Re: MMC Staff Parking Garage | 222 St. John Street | Level III Site Plan
Response to Public Comments

Thank you for coordinating the review of the Maine Medical Center Parking Garage project located at 222 St. John Street. This letter provides a summation of our responses to the comments received from various reviewers as part of the Level III Site Plan process. We have repeated the original comment in italics below, and our response follows each.

PHASE 2 LOGISTICS PLAN SUMMER 2019 - DECEMBER 2019

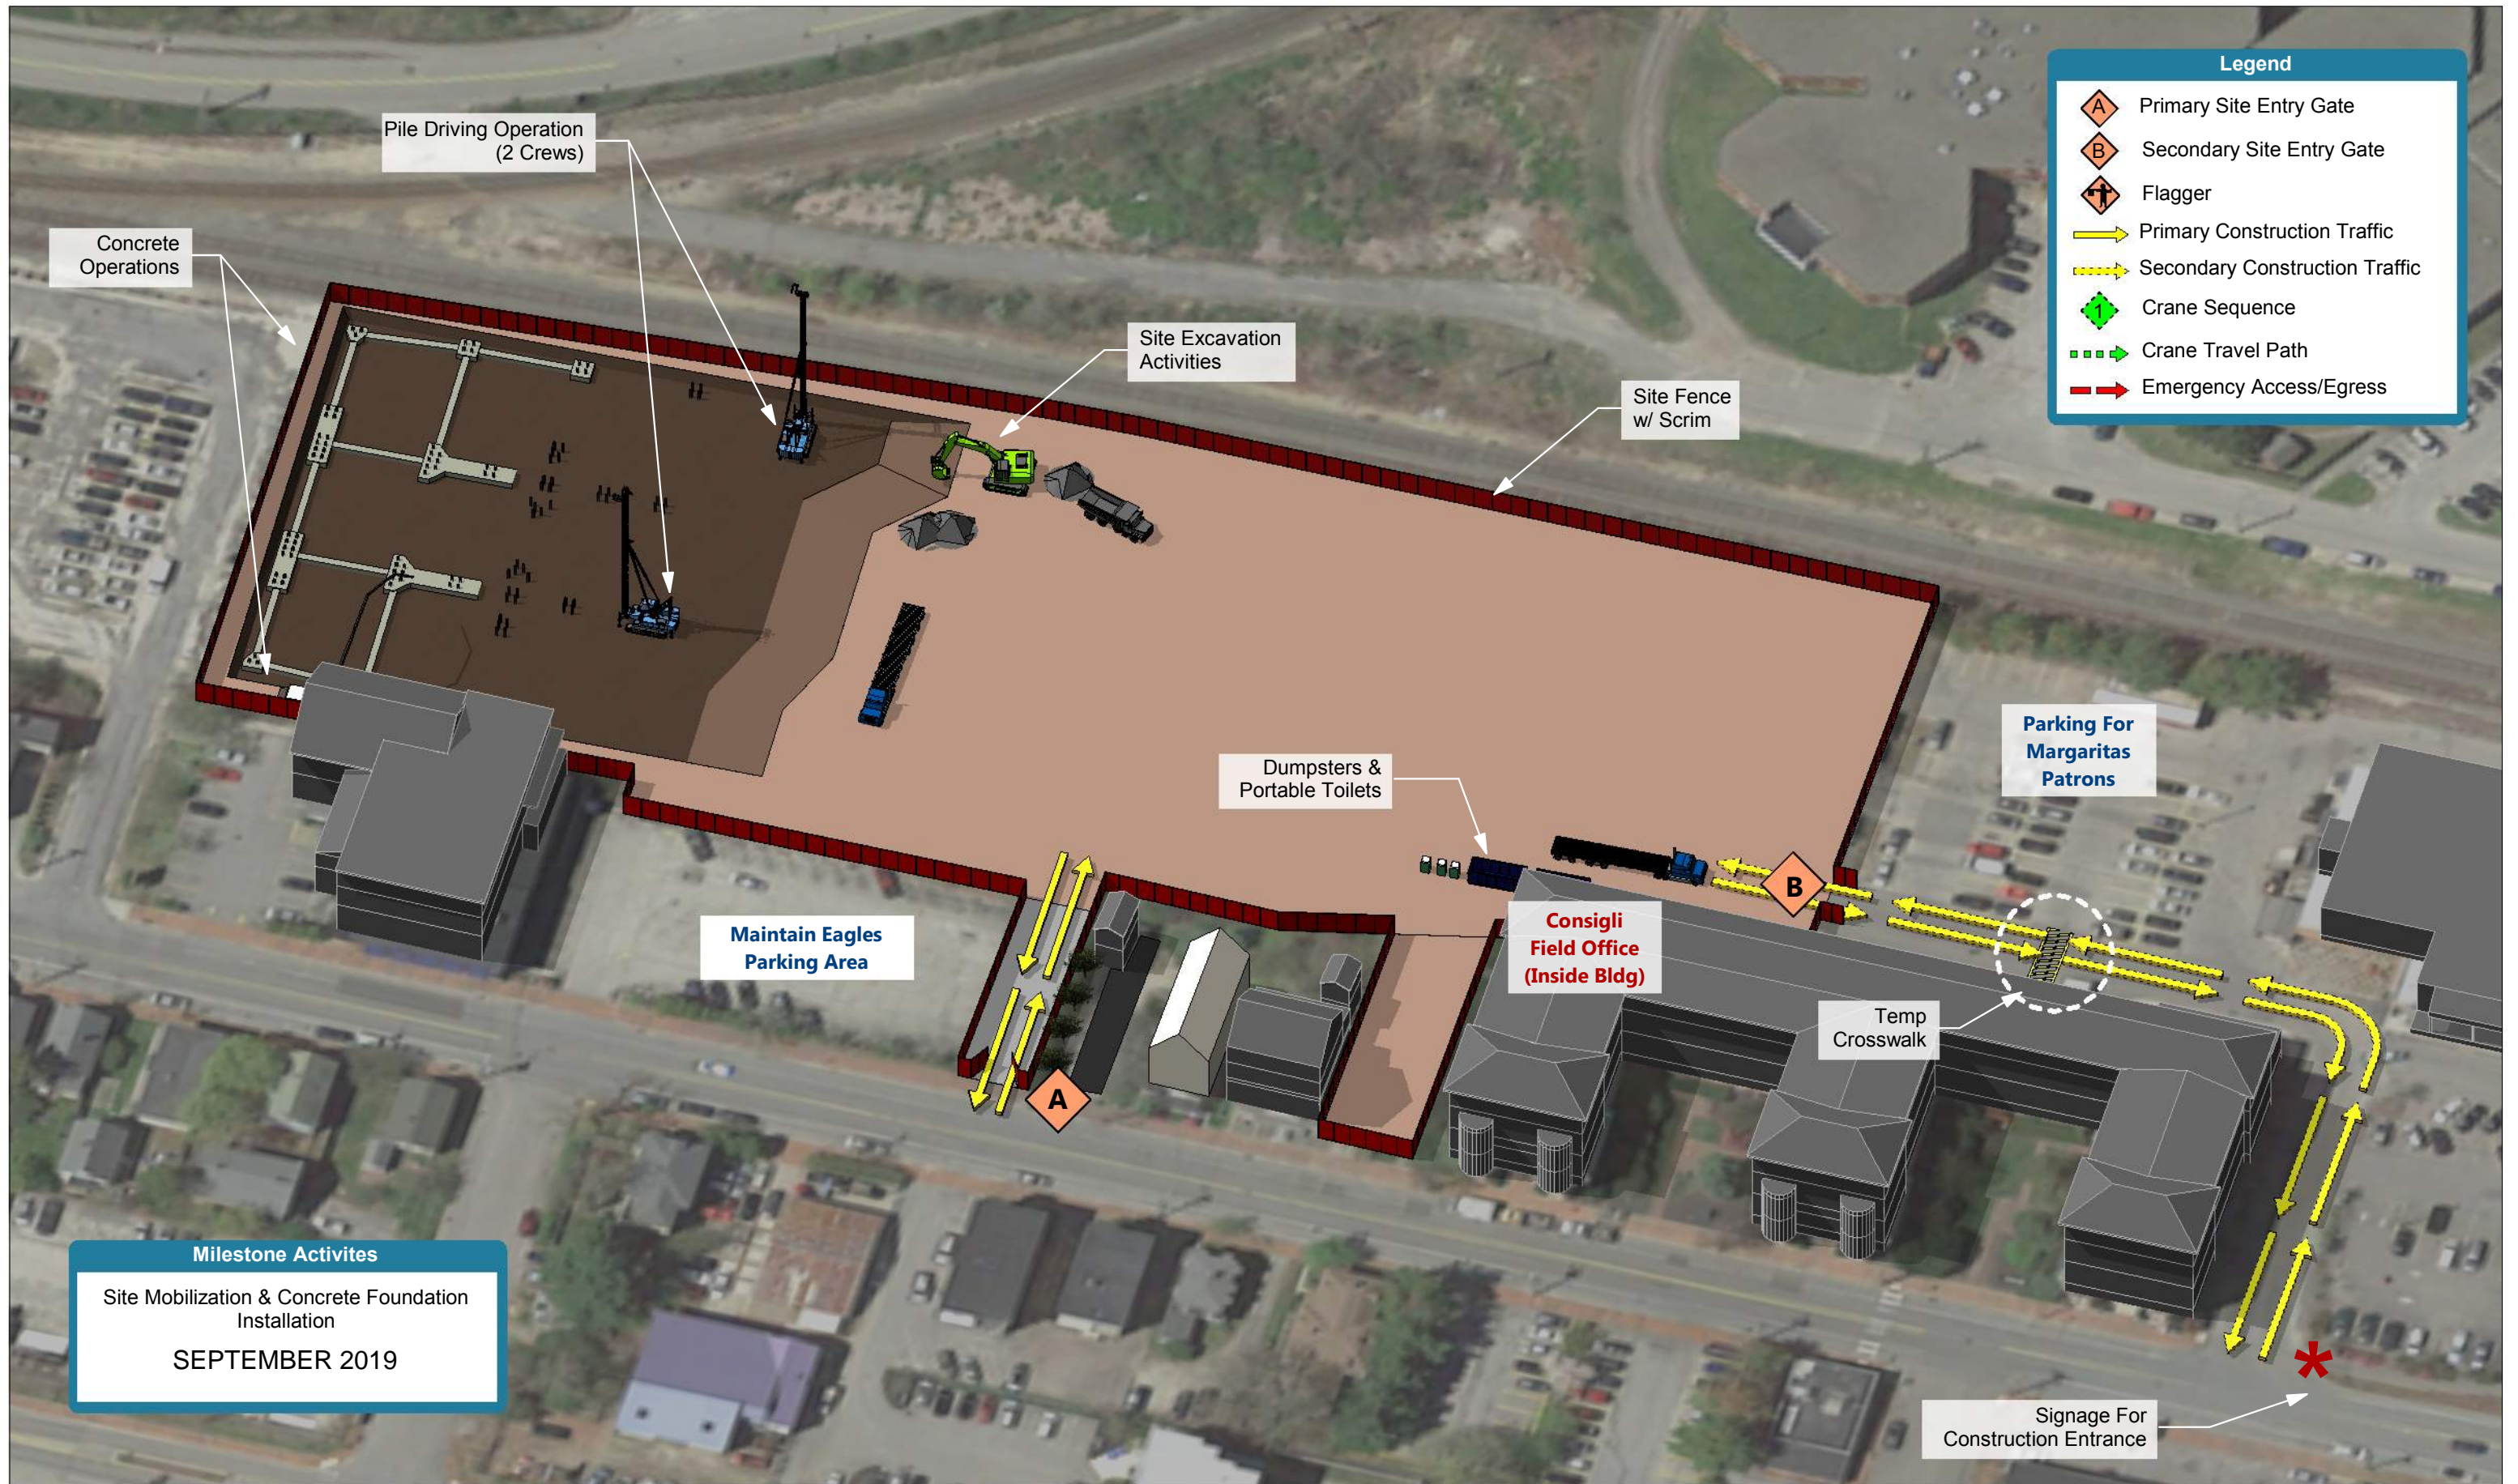
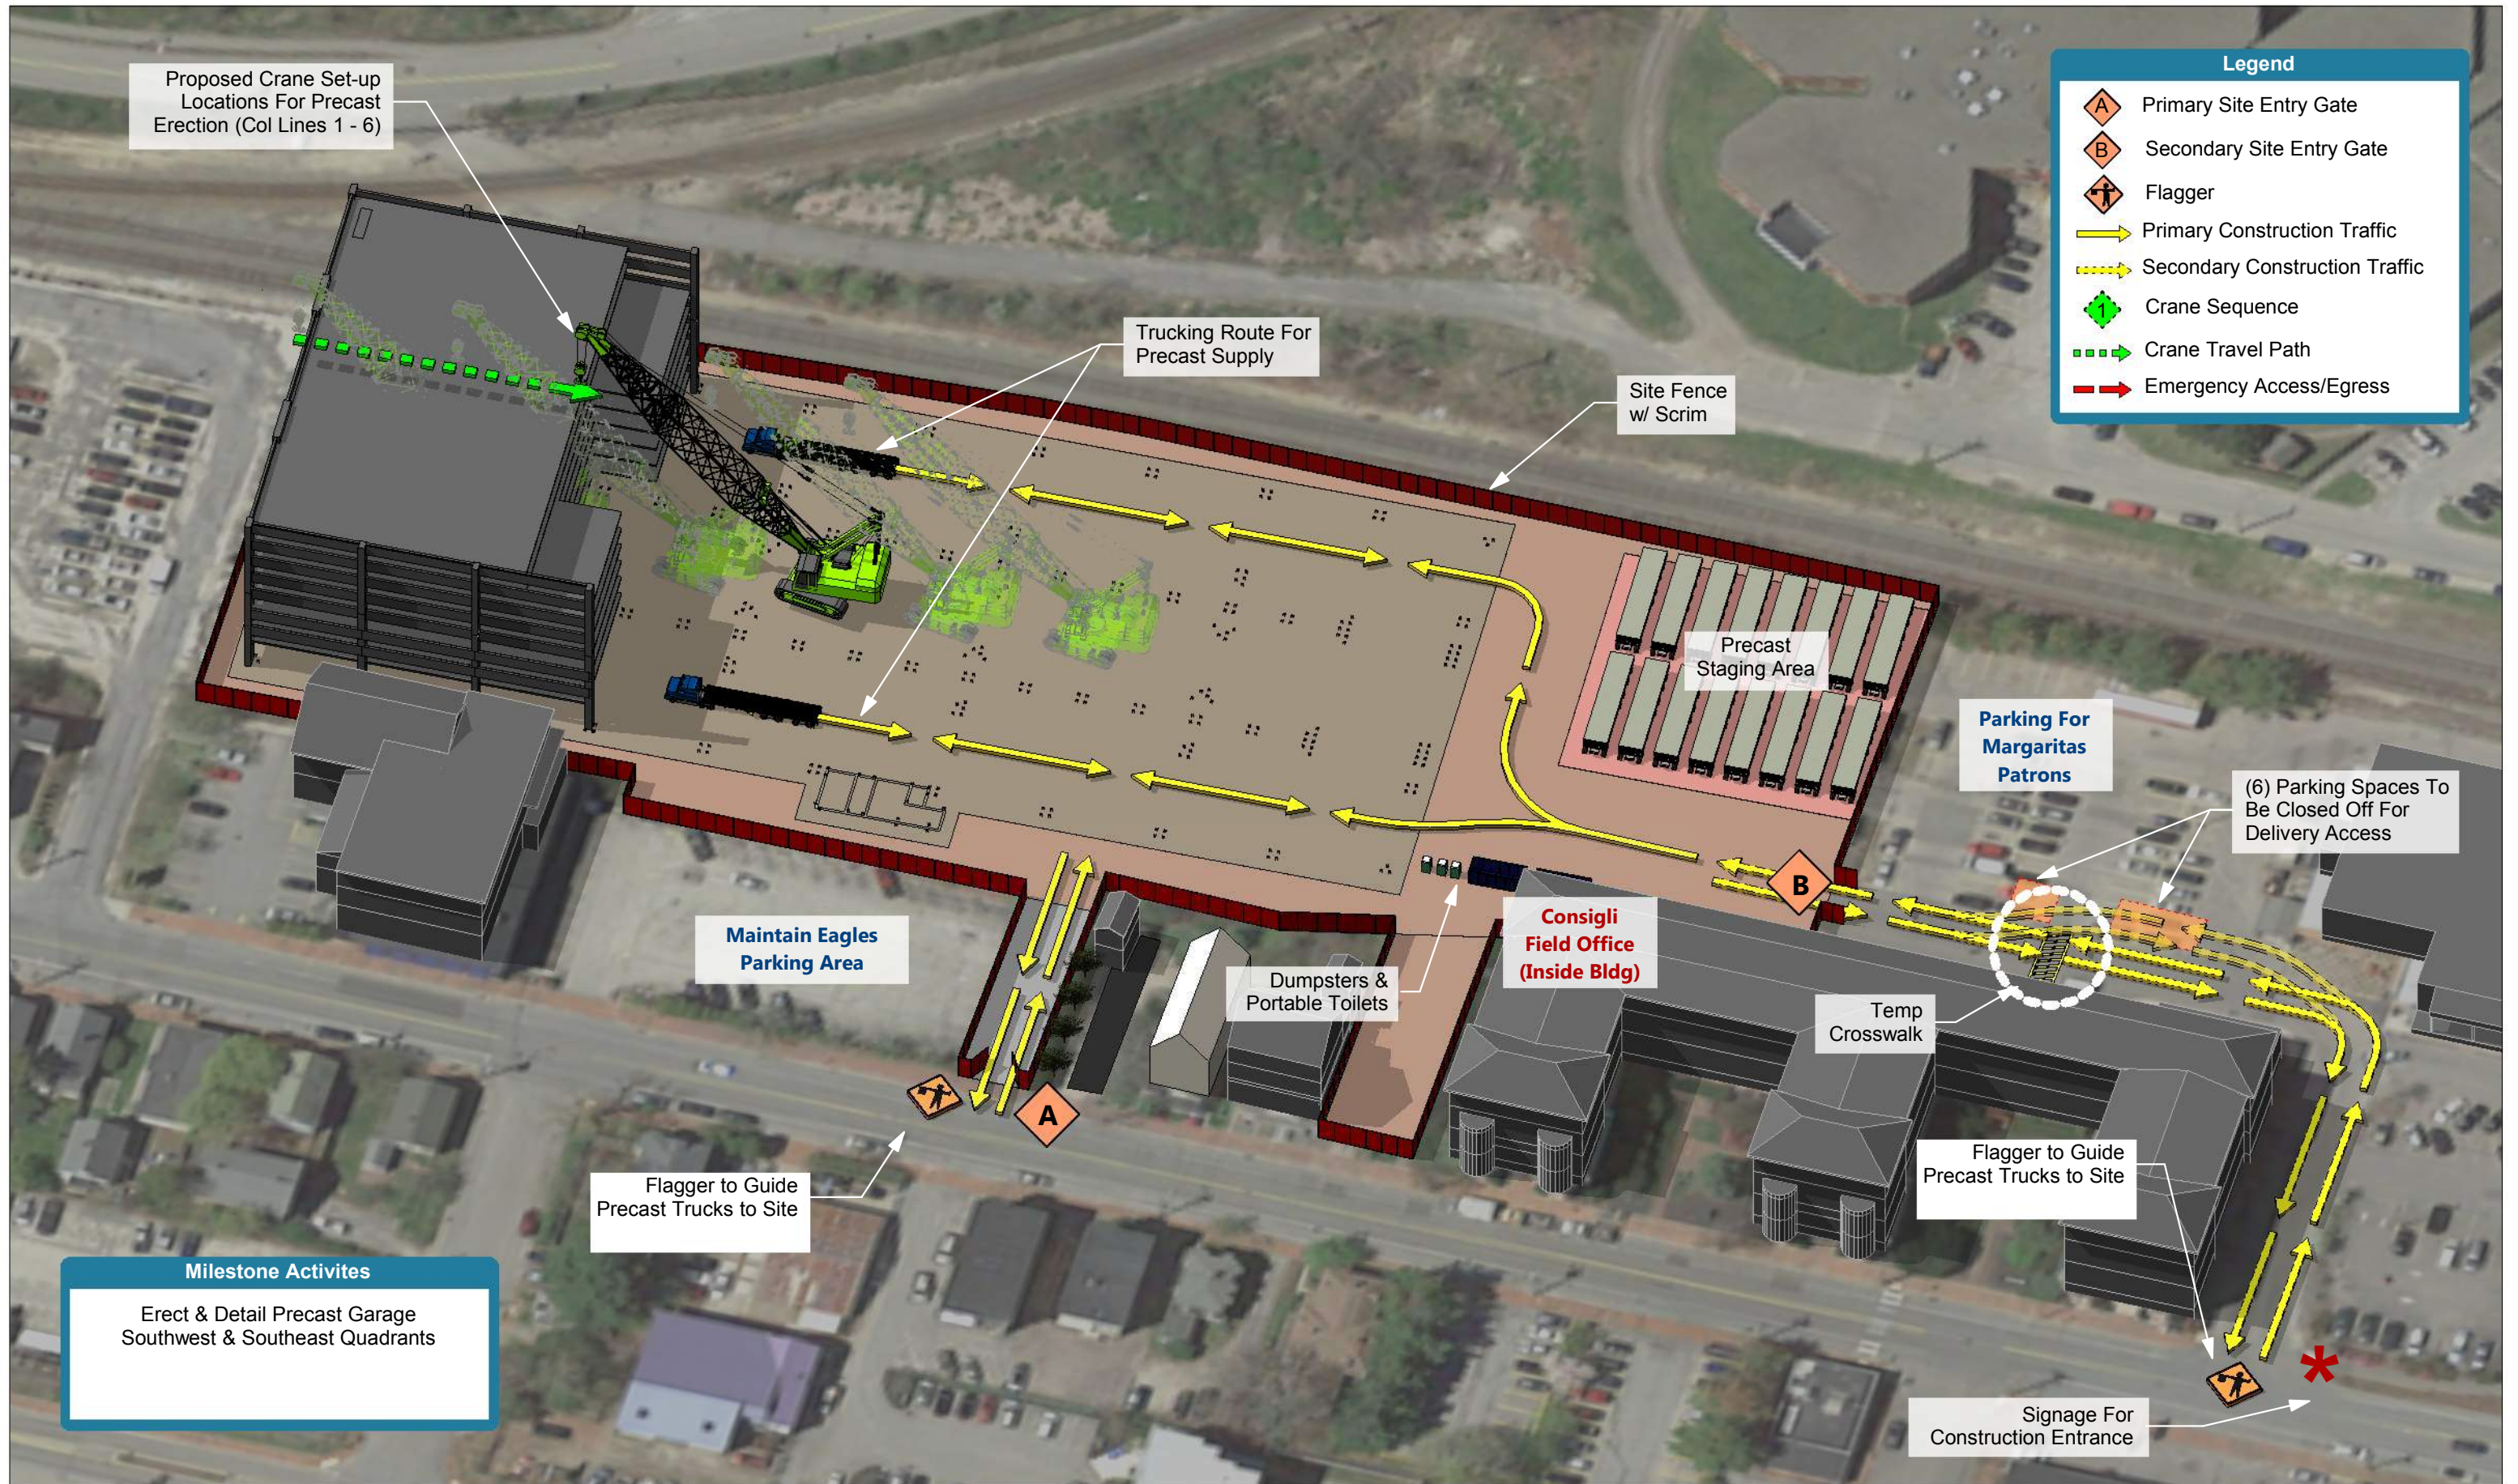
9. *Ped detour plan should include a temporary crosswalk at 210?*

Response: Included in the attached, updated CM Plan

WATER Quality Volume for Jersey Filter System

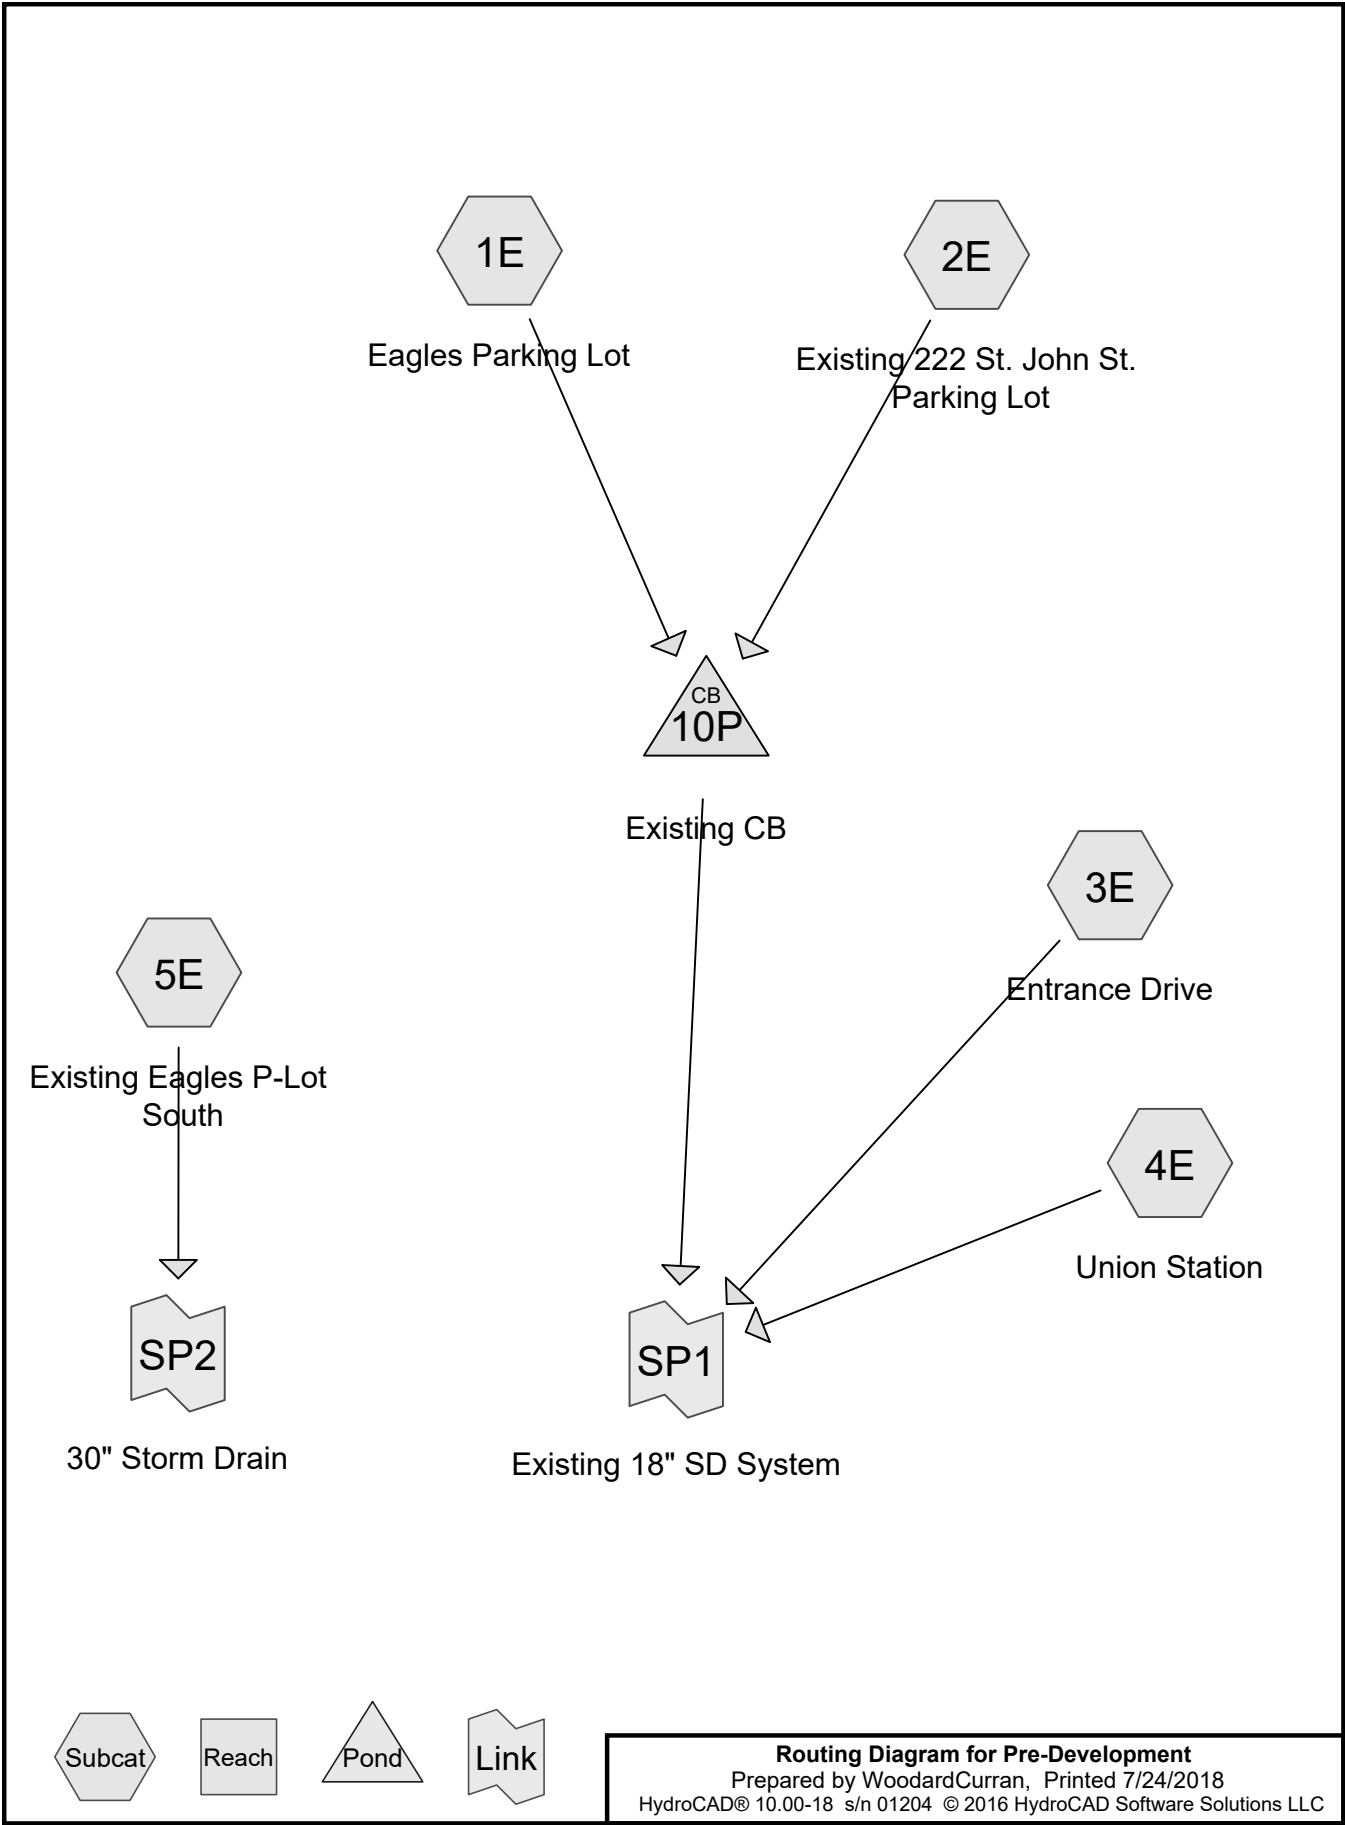
f. *The areas presented in the Water Quality Volume for Jellyfish Filter System calculations do not match those presented in Table 12-1 (see comment 1.b.i of this response). Please remedy.*

Response: Please refer to comment 1.b.i of this response letter, Water Quality Volumes have been revised and are further described within the attached revised Section 12 of the Level III Site plan Narrative.
